Access Compliance Report

Public Rights-of-Way

(Curb Ramps)

Intersection ID: 43075	Main Street: SCOTT_AV	Cross Street: ROMANY_RD	Location: NE
ADA ID: C72827F46A1B	Ramp Type: Perp	Initial Pass/Fail: Fail	Overall Compliance: No
Codes/Mitigation Info/Possible Solution			Severity Score: 46.25
			Field Measurements/Component Compliance

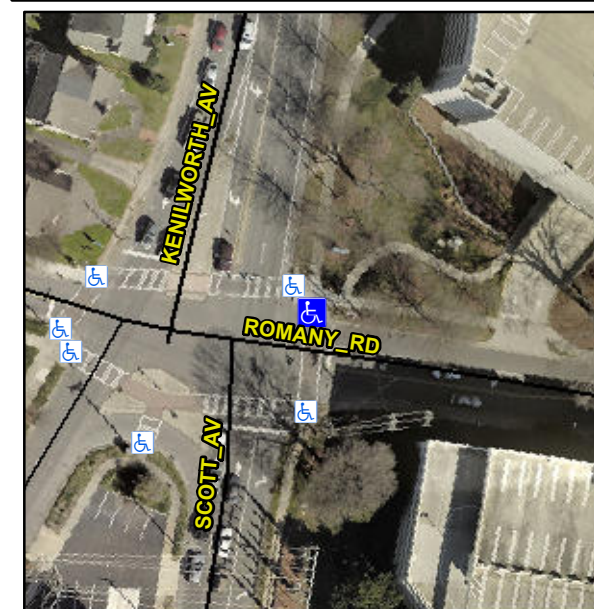
Not Found, R304.5.1, R304.2.2, R304.5.3

Compliance	Description	Data	Compliance	Description	Data
N/A	Ramp Length (in)	102.0	No	Ramp Slope (%)	12.2
No	Ramp Width (in)	47.5	No	Ramp XSlope (%)	6.8
N/A	Flare Type LT	N/A	N/A	Flare Type RT	N/A
N/A	Flare Slope LT (%)	N/A	N/A	Flare Slope RT (%)	N/A
N/A	Flare Traversable LT?	N/A	N/A	Flare Traversable RT?	N/A
N/A	Landing Length (in)	N/A	N/A	DWS Provided?	N/A
N/A	Landing Width (in)	N/A	N/A	DWS Contrast?	N/A
N/A	Landing Slope (%)	N/A	N/A	DWS Length (in)	N/A
N/A	Landing X Slope (%)	N/A	N/A	DWS Full Width?	N/A
N/A	Landing Curb? (Y/N)	N/A	N/A	DWS Offset (in)	N/A
N/A	Shared Landing?	N/A			
N/A	Gutter Ponding?	N/A	N/A	Gutter Slope (%)	N/A
N/A	Gutter Lip Ht (in)	N/A	N/A	Gutter X Slope (%)	N/A
N/A	Painted X Walk1?	Yes	N/A	Painted X Walk2?	N/A
	X Walk 1 Direction	To S		X Walk 2 Direction	N/A
N/A	X Walk 1 Width (in)	104.0	N/A	X Walk 2 Width (in)	N/A
	X Walk 1 Slope (%)	7.7		X Walk 2 Slope (%)	N/A
	X Walk 1 X Slope (%)	1.8		X Walk 2 X Slope (%)	N/A

Remove & Replace Entire Ramp.
